CITY OF ALBUQUERQUE

Re: Speculative Coffee
2509 San Mateo Blvd NE
Traffic Circulation Layout
Engineer's/Architect's Stamp **05-20-2019 (H17D116)**

NEW COMMERCIAL DEVELOPMENT FOR:
SPECULATIVE COFFEE
2509 SAN MATEO BLVD. ALBUQUERQUE, NM 87110

SHEET TITLE
SITE PLAN

CONCEPT SITE PLAN
SCALE: 1" = 10'-0"

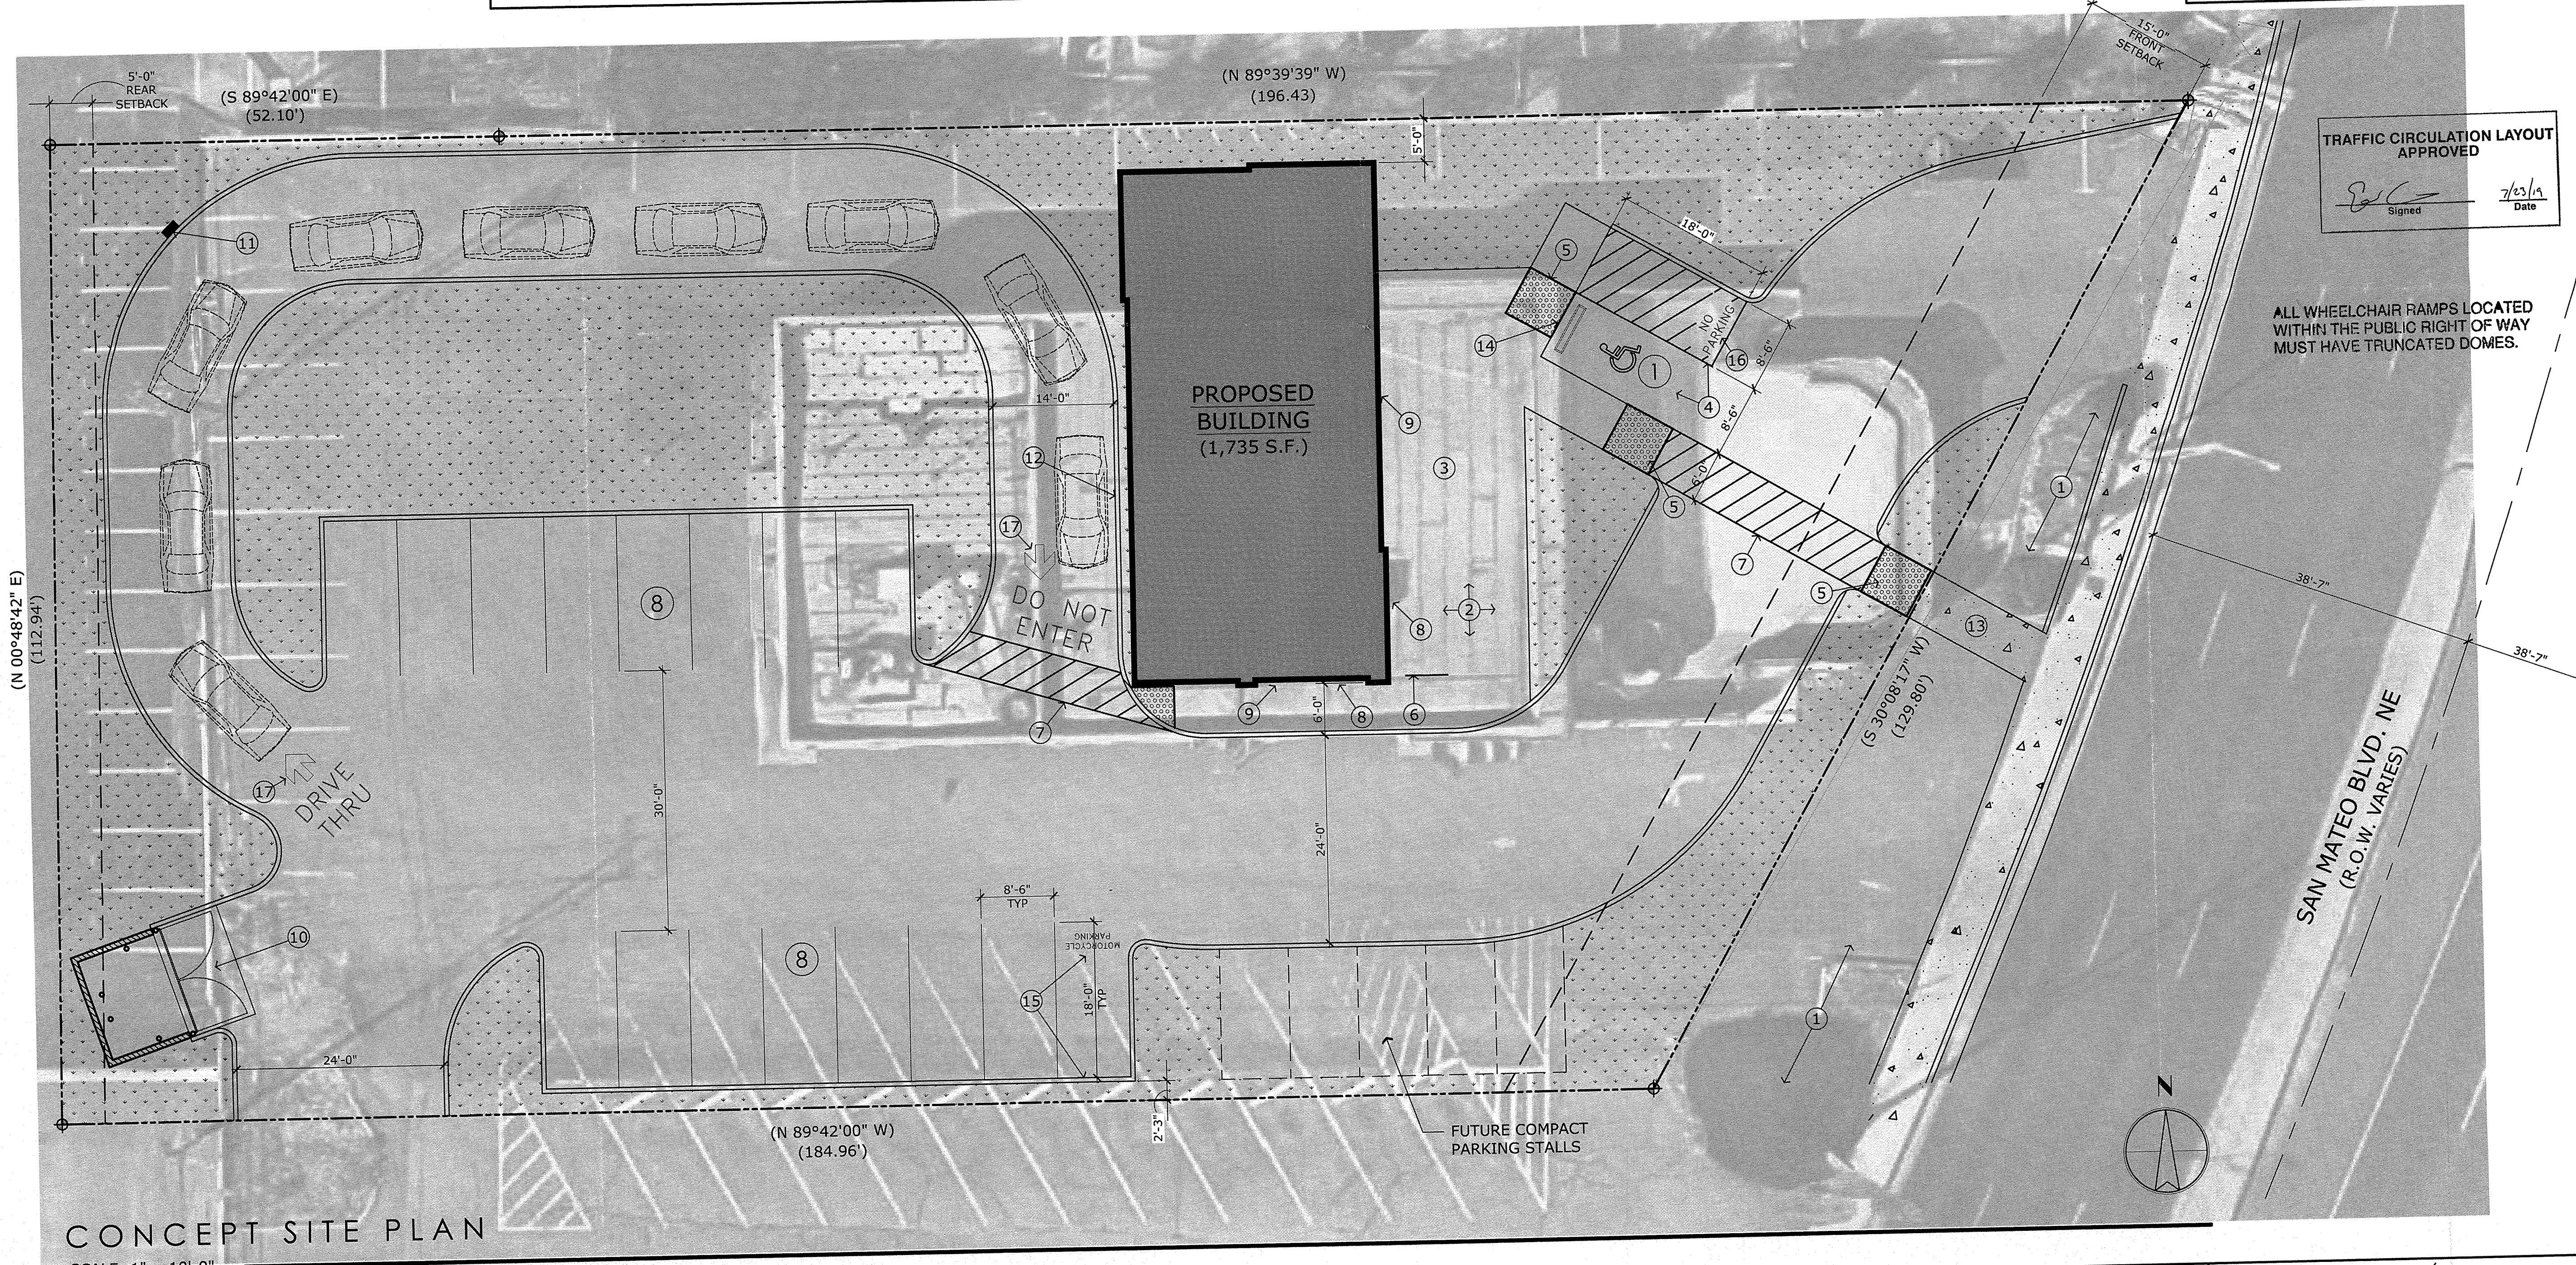
The TCL submittal received 07-23-2019 is approved for Building Permit with a condition of installing a "Do not Enter sign" which will be checked at the time of the certificate of occupancy. A copy of the stamped and signed plan will be needed for each of the building permit plans. Please keep the original to be used for certification of the site for final C.O. for Transportation.
